11/14/97	Plan revised to indicate pedestrian and bicycle safe grate GDI's.
DATE	REVISION
STATE OF HAWAII DEPARTMENT OF TRANSPORTATION HIGHWAYS DIVISION	
DRAINAGE PLAN	
VOLCANO RD. DRAINAGE IMPROVEMENTS	
Vicinity of Keau Town	
F.A. Proj. No. STP-011-2(30)	
Scale: 1"=40'	Date: Oct 1997
SHEET No. <i>HI</i> OF 6 SHEETS

DRAINAGE DETAILS
VOLCANO RD. DRAINAGE IMPROVEMENTS
Vicinity of Keaau Town
F.A. Proj. No. STP-011-2(30)
Scale: 3/4" = 1'-0"
Date: Oct 1997

STATE OF HAWAII DEPARTMENT OF TRANSPORTATION HIGHWAYS DIVISION
DRAINAGE DETAILS
VOLCANO RD. DRAINAGE IMPROVEMENTS Vicinity of Keaau Town F.A. Proj. No. STP-011-2(30)
Scale: 3/4" = 1'-0" Date: Oct 1997
SHEET No. H4 OF 6 SHEETS

DETAILS OF TYPE 61614P DRYWELL AT STA. 1063+00 LT.

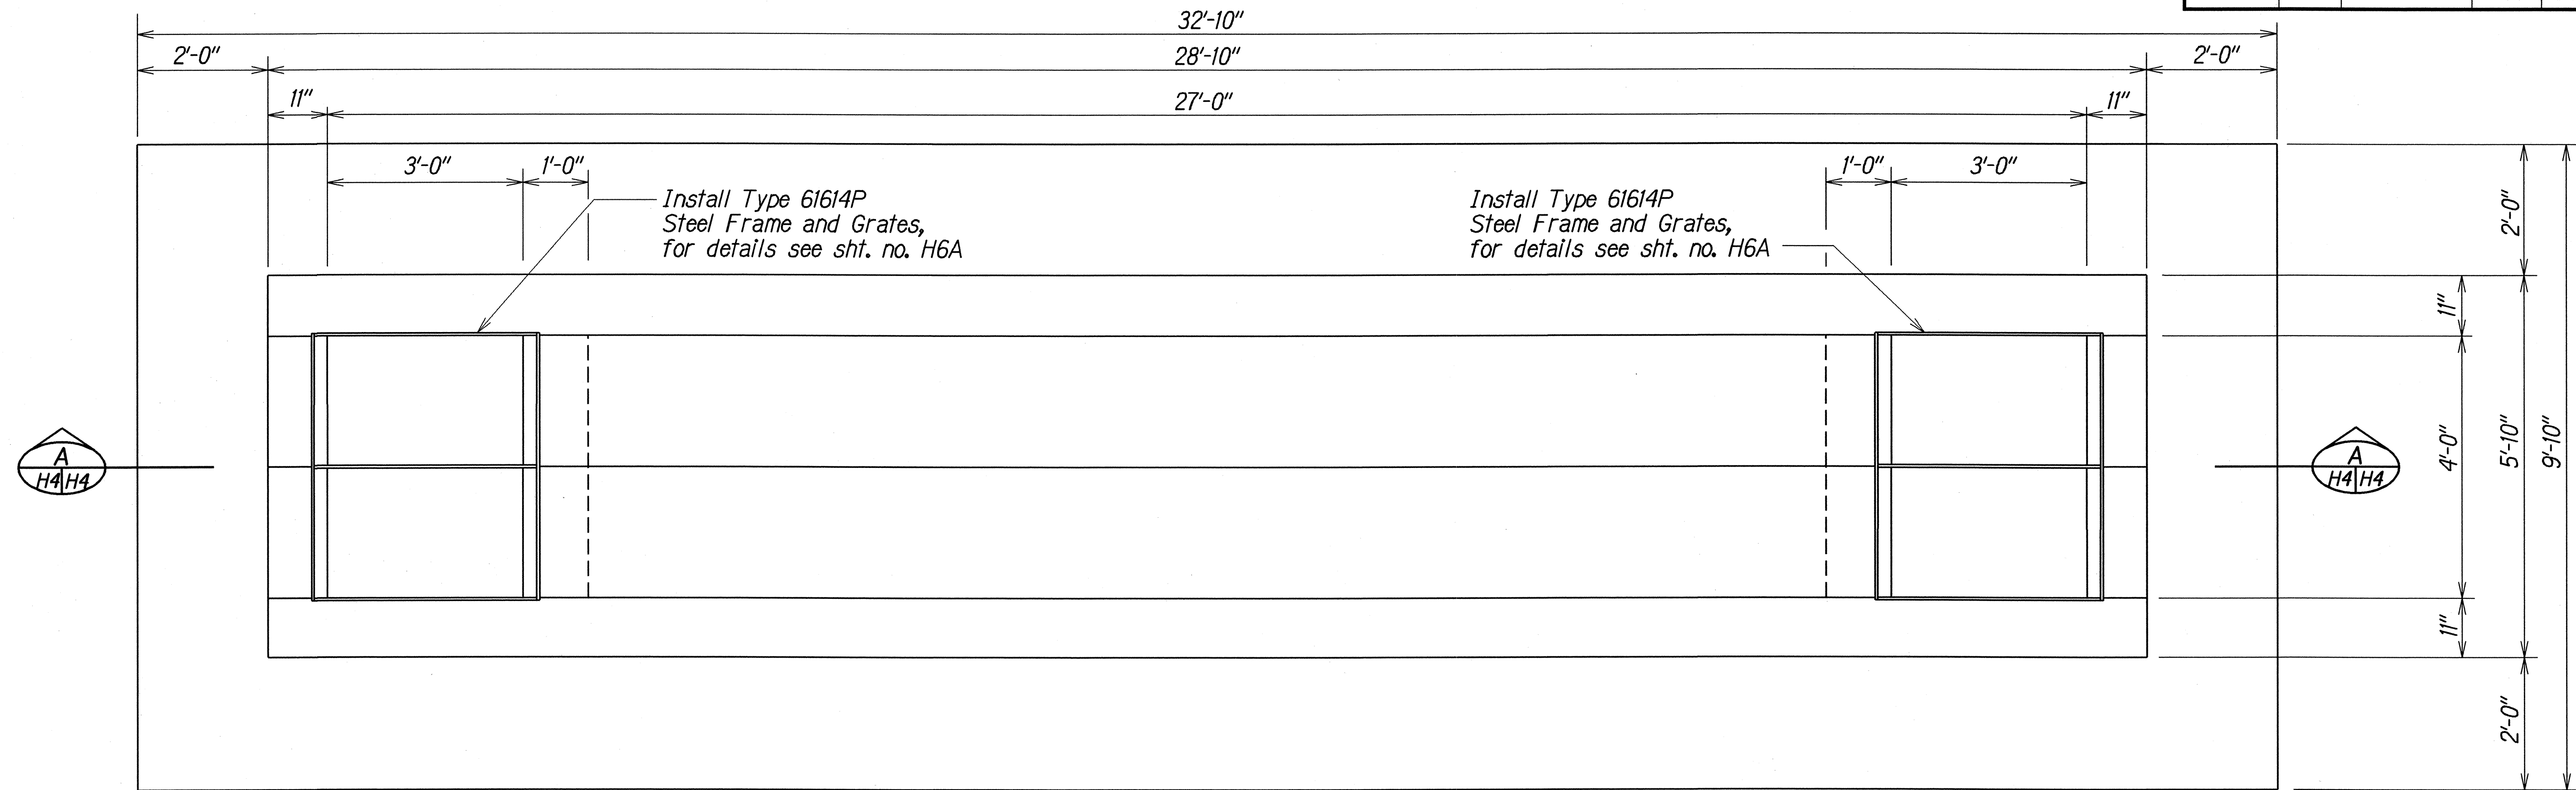
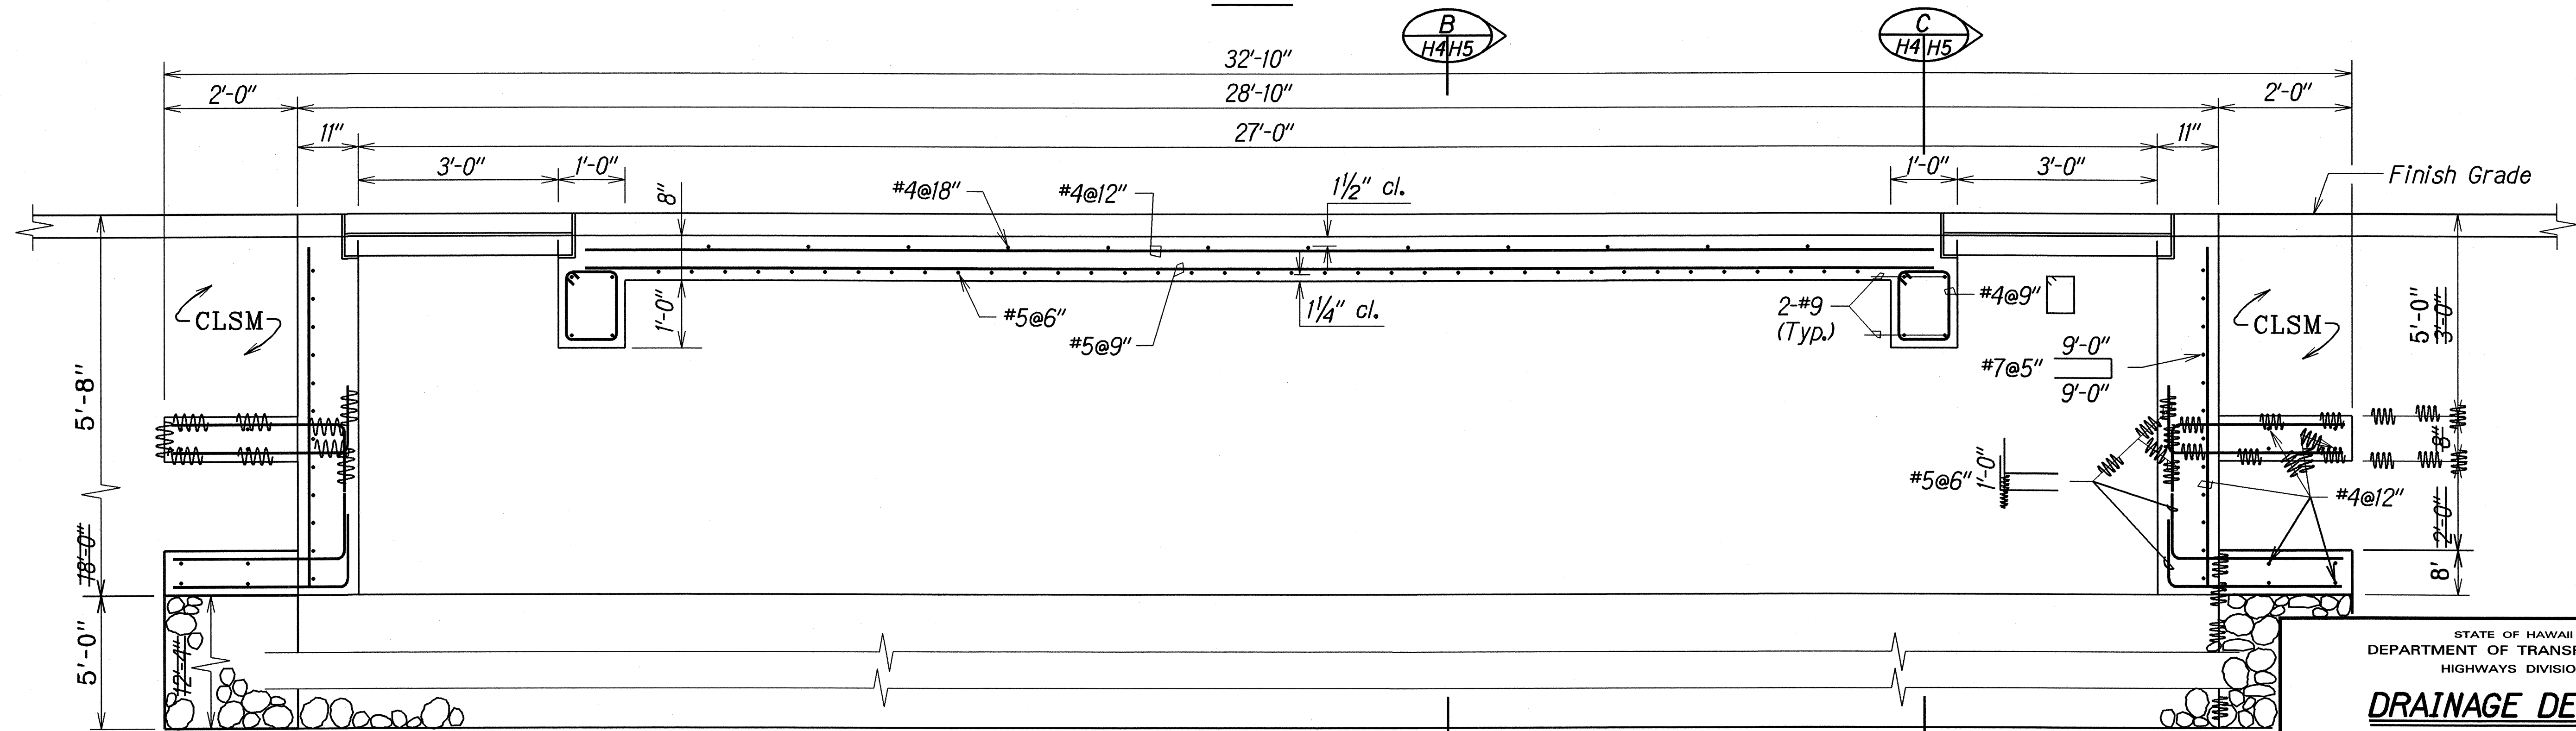
11/14/97	Revised to make grates pedestrian and bicycle safe.
DATE	REVISION
